**REDEFINE THE DRIVE**

## North Lake Shore Drive Small Group Discussion Common Questions and Responses Summary

The following questions were collected during the North Lake Shore Drive Public Input Opportunity small group discussions that took place on Tuesday, October 13 and Wednesday, October 14. This is not a comprehensive review of all questions posed at these meetings, but a summary of the common questions and themes.

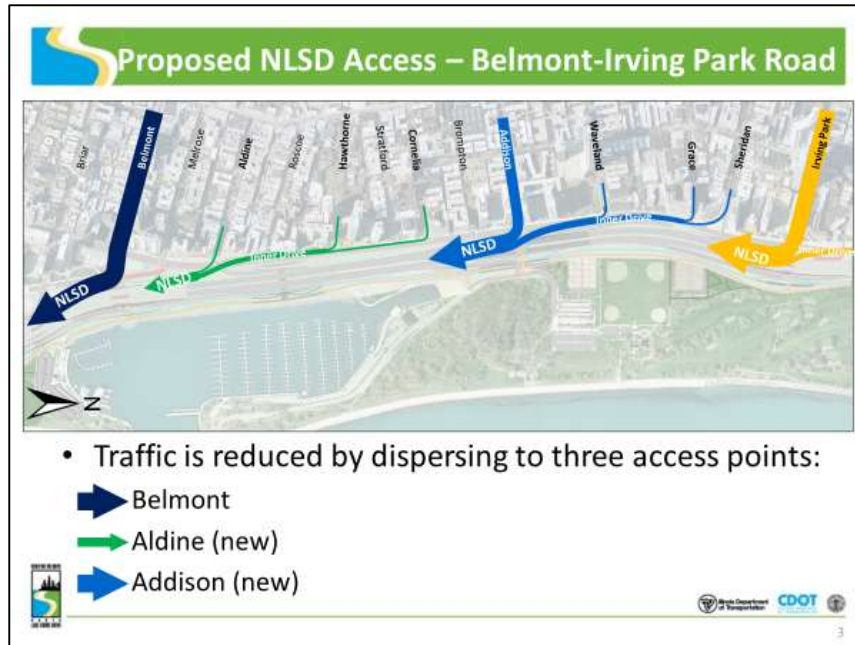
**Why do the proposed plans include southbound entrance and exit ramps at Aldine Avenue?  
The proposed plans could attract unwanted traffic onto this community street.**

Under existing conditions, the junction at Belmont must serve traffic coming from six different areas:

- 1) Traffic from the west on Belmont
- 2) Traffic from south of Belmont (limited catchment area that prefers Belmont over Fullerton)
- 3) Traffic from the east (South Belmont Harbor parking lot)
- 4) Traffic from the area between Addison, Inner Drive, Aldine, and Broadway (via Inner Drive)
- 5) Traffic from the west on Addison or north on Broadway (via Inner Drive)
- 6) Traffic from north of Addison (limited catchment area that prefers Belmont over Irving Park)

This is too much traffic for the Belmont on-ramp and nearby intersections to handle effectively, and traffic backs up regularly, affecting motorists and buses alike. These back-ups also cause some motorists to seek short-cuts using neighborhood streets; for example, some motorists from the west on Addison or the north on Broadway have been observed to cut through on Aldine to try to avoid delays on Inner Drive or Belmont.

To reduce congestion and improve safety, in the proposed configuration these six traffic movements would be re-allocated to three future on-ramps at Addison, Aldine, and Belmont (*please reference the existing traffic areas numbered above to correspond with the new movements below*).

- Belmont will serve traffic from areas (1) (2) and (3)
- Aldine will serve traffic from area (4)
- Addison will serve traffic from areas (5) and (6)

Because delays on Belmont will diminish, and traffic from Addison and points north and west will be able to enter directly at Addison without getting delayed on Inner Drive or Belmont, it is expected that there would no longer be demand for traffic to cut through from Broadway to Inner Drive using Aldine. However, the project team is developing additional alternatives for this area based on community input, and we anticipate hosting community meetings in 2021 to present this and receive additional input.

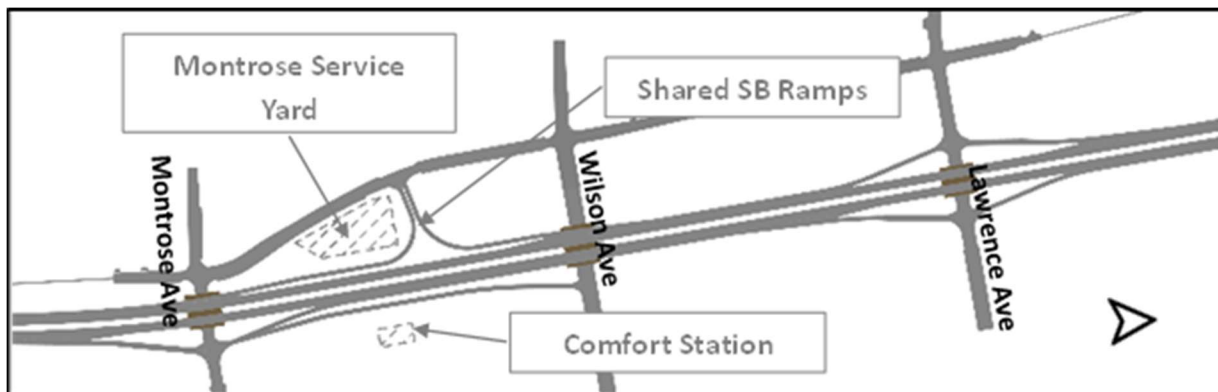
**Does the proposed plans include the Lakeview Dog Park and the Belmont Harbor dog beach?**

The proposed plans for the Lakeview Dog Park are being taken into consideration by the project team and will be addressed in coordination with the Chicago Park District and community stakeholders. The Belmont Harbor dog beach is proposed to be maintained but relocated to a nearby area within the reconfigured Belmont Harbor.
